SERVICE BULLETIN No PA SB0901

SUBJECT: 3-RING RISER INSPECTION

IDENTIFICATION: All 3-ring risers manufactured by Parachutes Australia

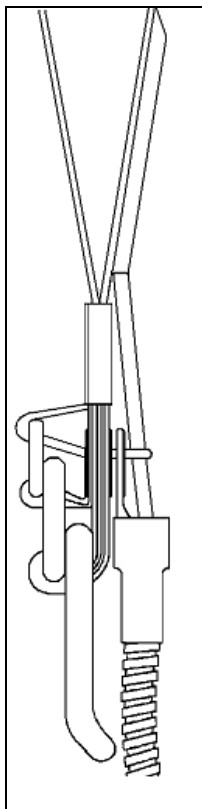
Older versions of PA 3-ring risers have a shorter loop than now in common use. All 3-ring risers manufactured by PA can remain in service provided they meet the following requirements as extracted from the APF Service Bulletin APF010801-C

While 3-ring risers may be constructed of different materials the following points define the proper criteria for a correctly built 3-ring riser when attached to the harness ring and put under moderate tension.

- The rings should overlap each other and maintain metal to metal contact between each other.
- The rings should be aligned in parallel planes.
- The smallest ring should not be pulled snug against the grommet by the locking loop which should be long enough to give it some play.
- The locking loop should go straight through the riser grommet on its way to the cable housing end fitting.
- It should be checked that NO suspended load is supported by the cable housing and locking loop due to the cable housing being incorrectly positioned in the harness or being too short.

PA manufactured 3- ring risers **not** meeting the requirements of APF Service Bulletin APF010801-C must be sent to PA for correction and return at no charge.

The owners of PA manufactured 3- ring risers that have locking loops shorter than that as detailed in the above mentioned Safety Notice but **do** meet the requirements of APF Service Bulletin APF010801-C that feel uncomfortable about the length of the locking loops can also send them to PA for lengthening and be returned at no charge.
